AS CONSTRUCTED

URBAN DRAINAGE AND FLOOD CONTROL DISTRICT				
CITY AND COUNTY OF DENVER				
DEPARTMENT OF PUBLIC WORKS				
WASTEWATER MANAGEMENT DIVISION				
PROJECT NO. W 75-048				
WEIR GULCH DRAINAGE IMPROVEMENTS				
CONDUIT & OUTLET PLAN & PROFILE				
BARNUM LAKE EMBANKMENT IMPROVEMENTS				
DATE 2-18-77	SCALE HORIZ. 1"=50' VERT. 1"=5'	DRAWN GROUP CHECKED DATE	SHEET NO. 1725 OF 19 SHEETS	DWGN. NO. DI-03-75

URBAN DRAINAGE AND FLOOD CONTROL DISTRICT
CITY AND COUNTY OF DENVER
 DEPARTMENT OF PUBLIC WORKS
 WASTEWATER MANAGEMENT DIVISION
 PROJECT NO. W75-048
WEIR GULCH DRAINAGE IMPROVEMENTS
 EMBANKMENT AND CONDUIT PLAN
BARNUM LAKE EMBANKMENT IMPROVEMENTS

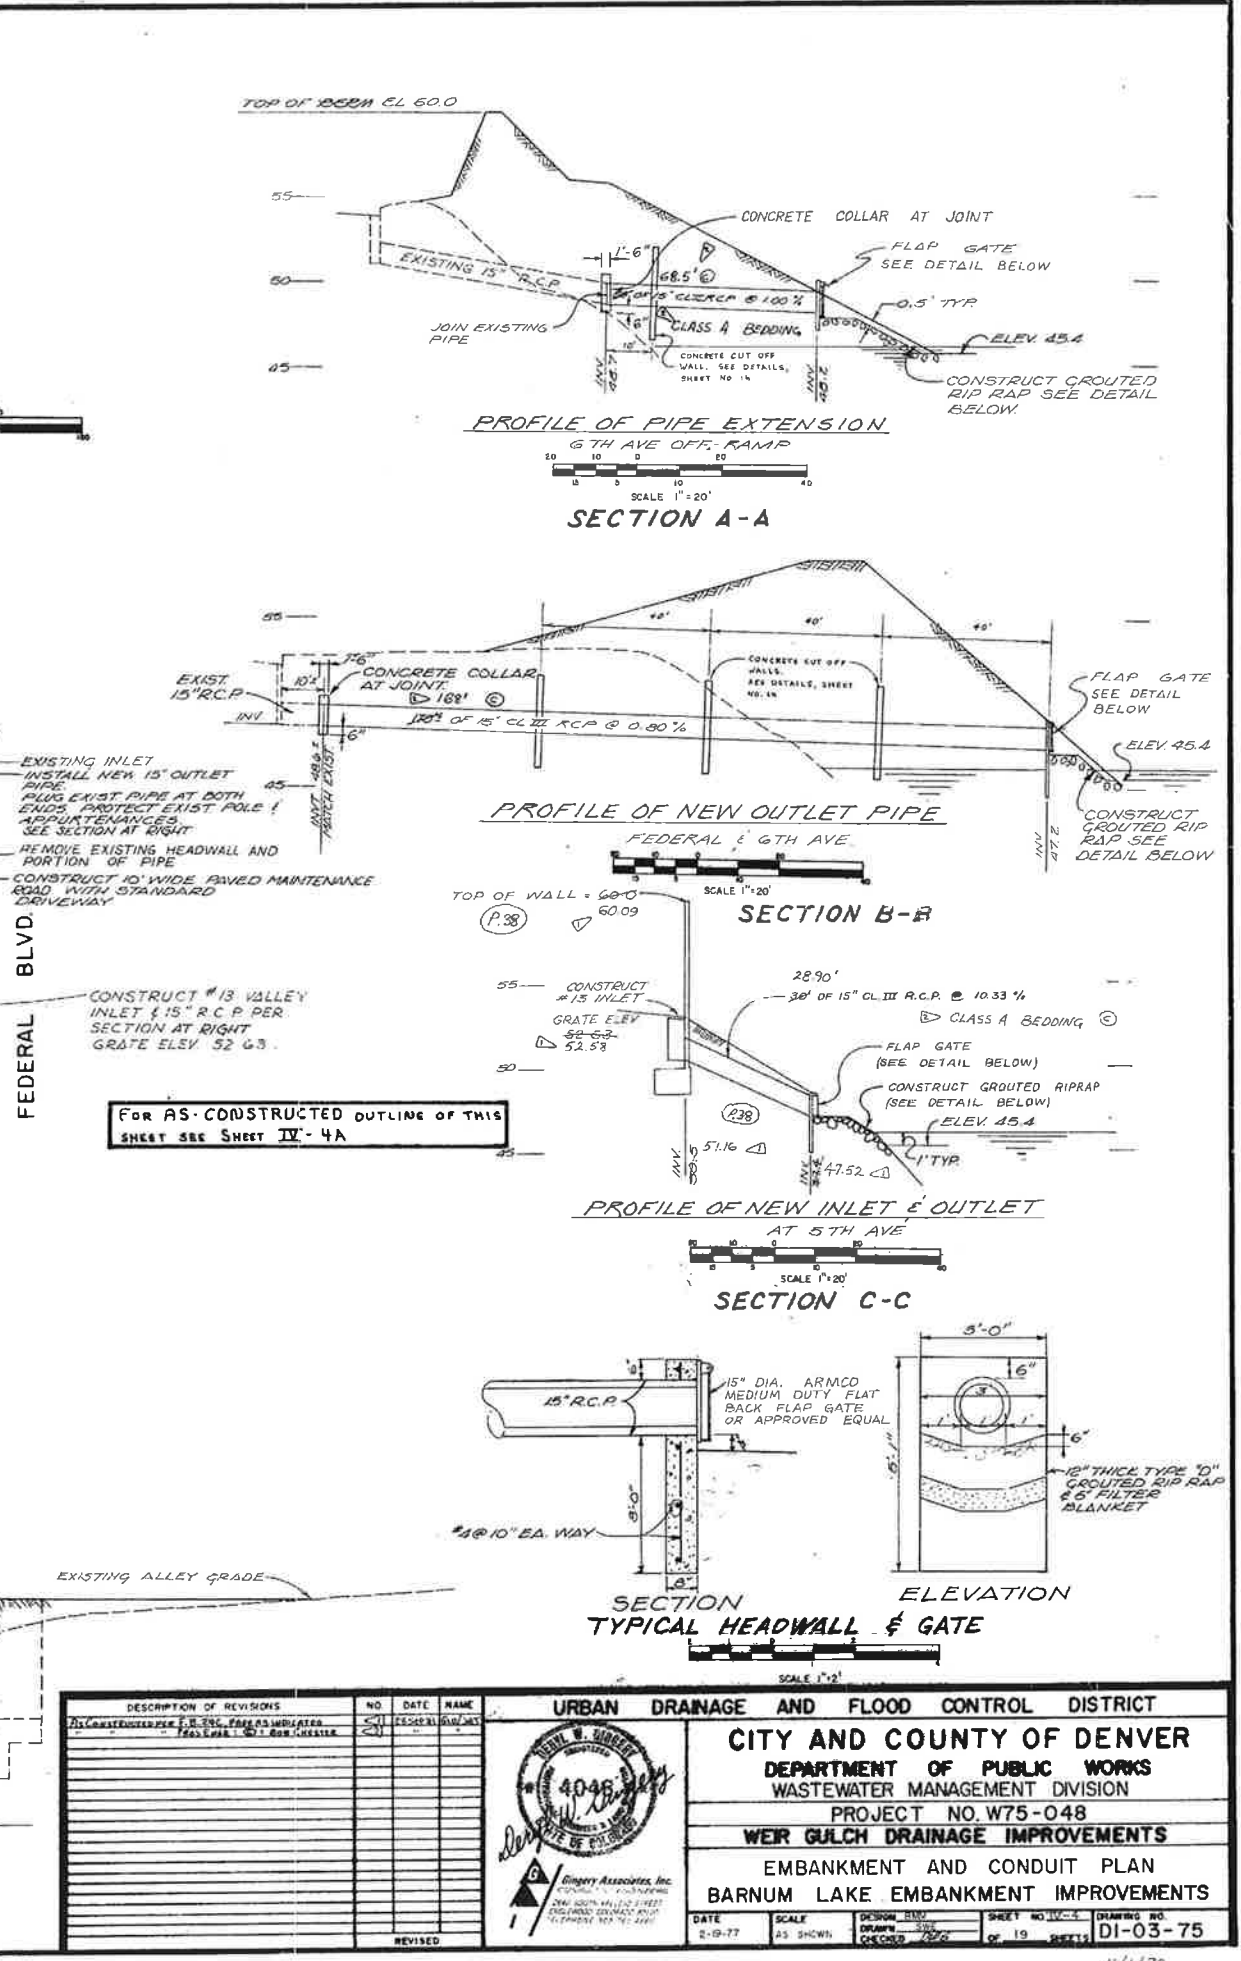
DESCRIPTION OF REVISIONS				NO.	DATE	NAME
1.	CONVERTED FROM 8\"/>	2.	ADDED 1\"/>

Why the 66" new tunnel is 16' longer: PASAL used one joint of 66" sack type 8" long to push the pipe to 0+00 (begin tunnel). As the rig and rails were set up, the extra pipe was needed because the jacking device couldn't reach Sta 0+00. The other 8" was an apparent miscalculation or error from the plans.

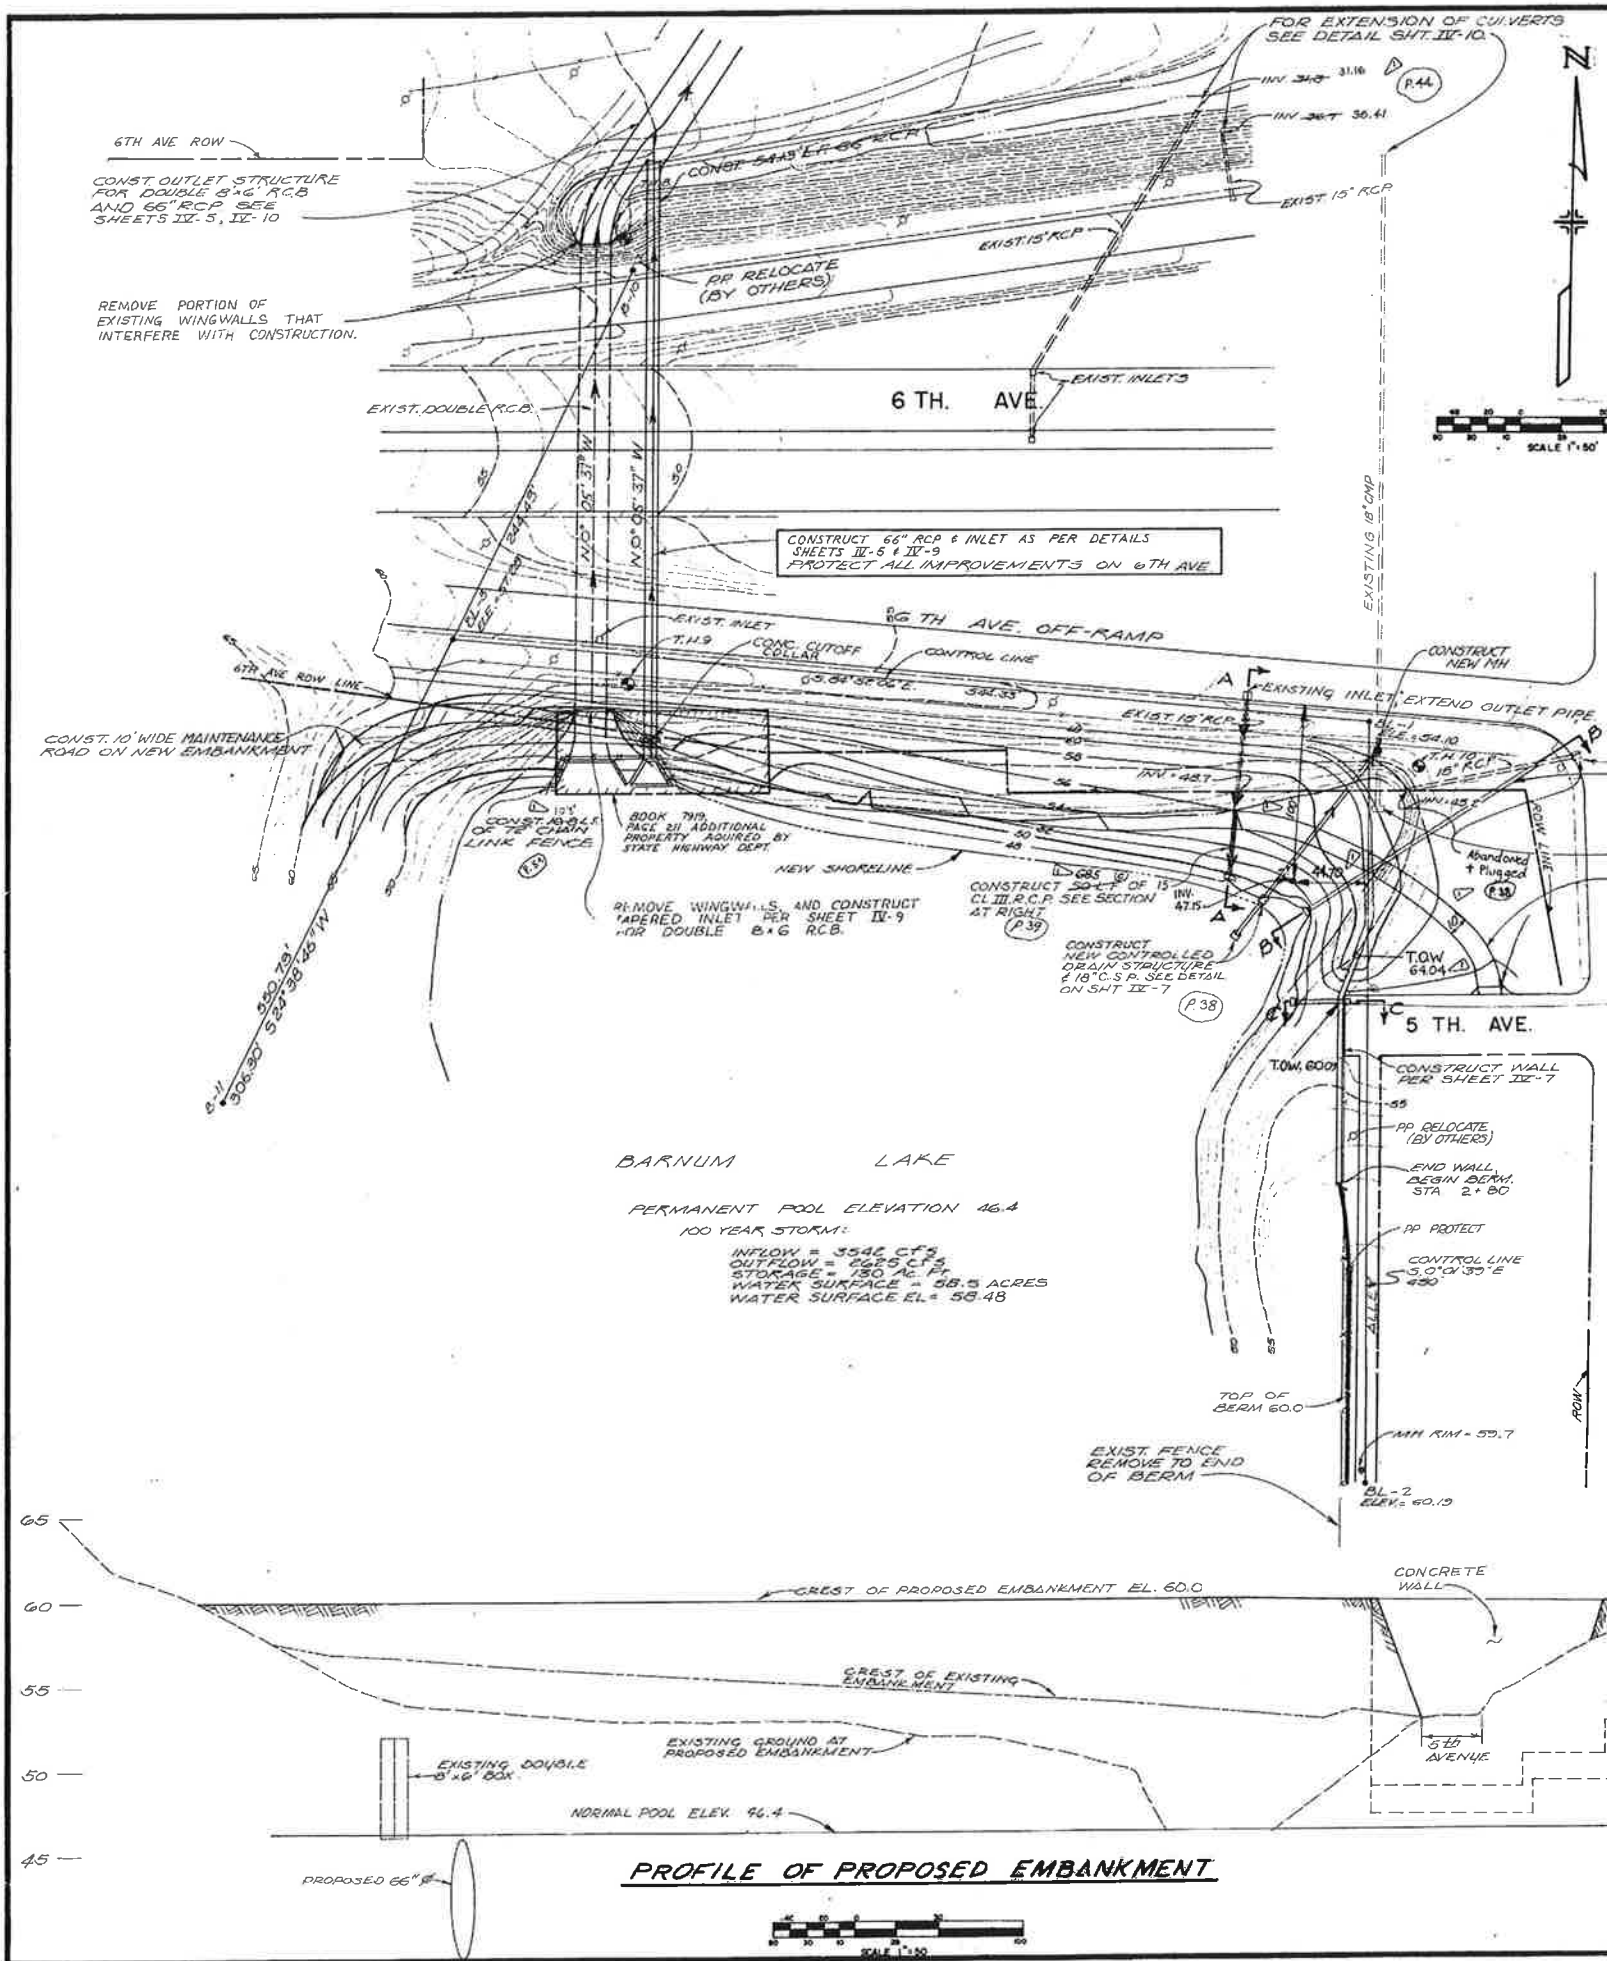
DESCRIPTION OF REVISIONS	NO.	DATE	NAME
CONSTRUCTED PER P.E. ENG. PARADISE/DAVID	1	10/20/77	DAVID
FOR ELEV. 1.0' BURN/DAVID	2	10/20/77	DAVID
